Request of Class II Permissive Change
Company name: Harman International Industries, Inc.
FCC ID: APIJBLGO3H
FCC Part 15 Certification

This is to request a Class II Permissive Change for FCC ID: APIJBLGO3H originally granted on 06/01/2020

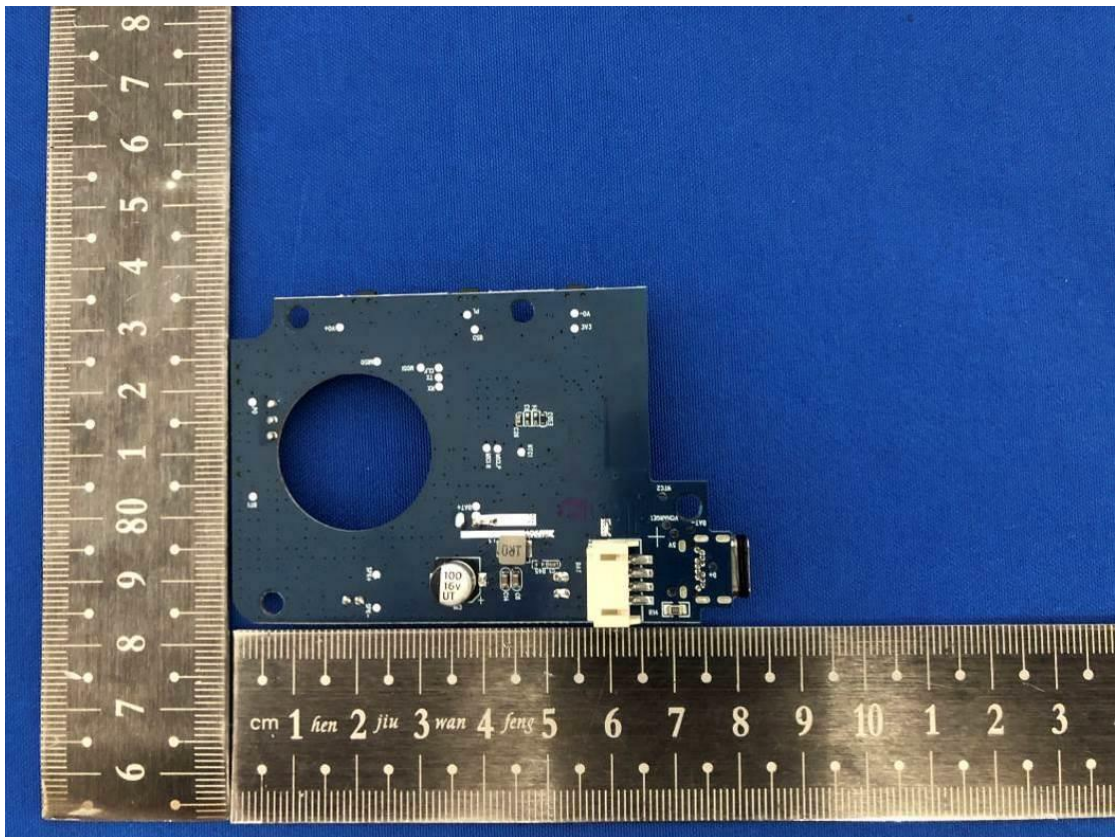
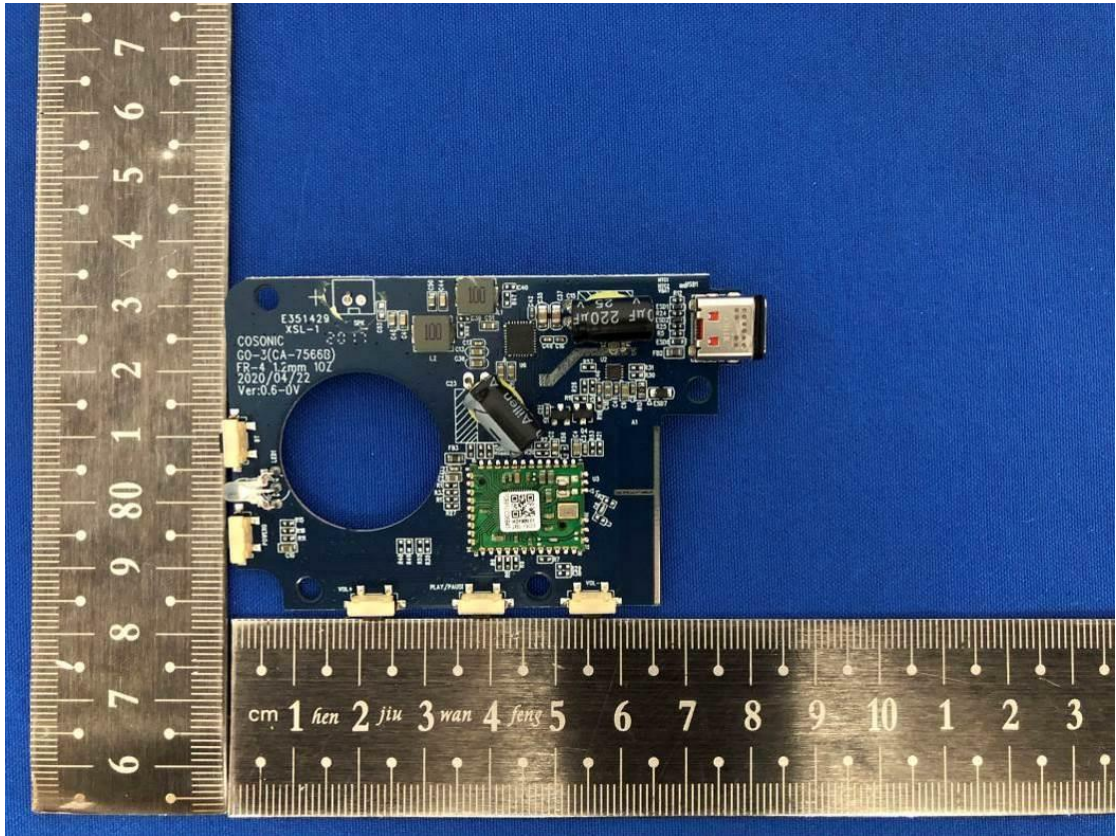
Compared with the original case, added IC (Mode: IC-AWBB298-QFN), diode and capacitor, the capacitor is changed to SMD type, this change doesn't influence the RF performance.

Original:

New: IC-AWBB298-QFN
